**Camp Far West Auxiliary Spillway Project
Federal Energy Regulatory Commission Project No. 2997
Yuba and Placer Counties
Bear River**

DENIAL WITHOUT PREJUDICE OF WATER QUALITY CERTIFICATION FOR CAMP FAR WEST AUXILIARY SPILLWAY PROJECT

Figure A5. Side by side zoomed in photos of Figures A1-A4. Top left – 2016; Top right – 2018; Bottom left – 2021; and Bottom right – 2022.

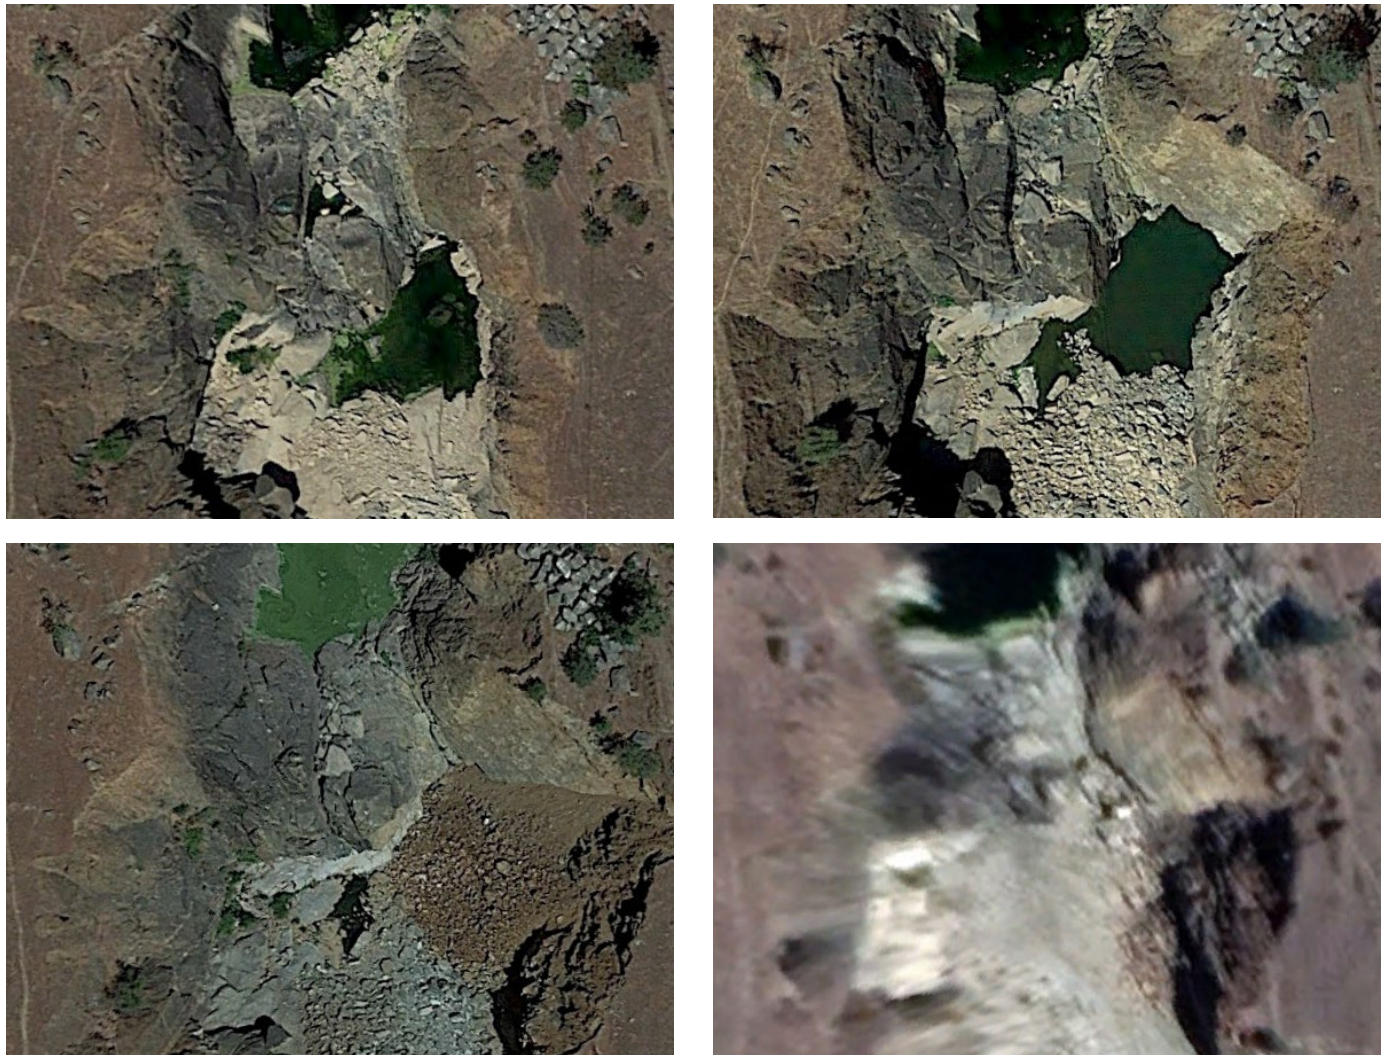
The State Water Board has ongoing concerns that the Project design and associated proposed operations do not comply with the SR/SJR Basin Plan sediment, settleable material, suspended material, and turbidity water quality objectives as the left side wall of one of the existing spillway's plunge pools is unstable and, based upon aerial photos, is actively eroding into the Bear River. Additional information regarding Project impacts on sediment discharges and measures that will be implemented to ensure protection of water quality and beneficial uses is needed for the State Water Board to determine whether a certification should be issued. Modifications to the Project design may also be needed to comply with water quality standards.

Based on available information, including staff’s independent analysis of ongoing erosion at the plunge pools (Attachment A), SSWD is hereby notified that SSWD’s February 17, 2022 request for certification for the Project is denied without prejudice, effective the date of this letter. The State Water Board encourages SSWD to submit a new request for certification once SSWD has adequately addressed the Project’s potential to exceed SR/SJR Basin Plan water quality standards, which may be accomplished through additional information or a revised Project description clarifying dewatering activities and erosion and sediment discharge potential associated with the design, construction, and operation of the auxiliary spillway.
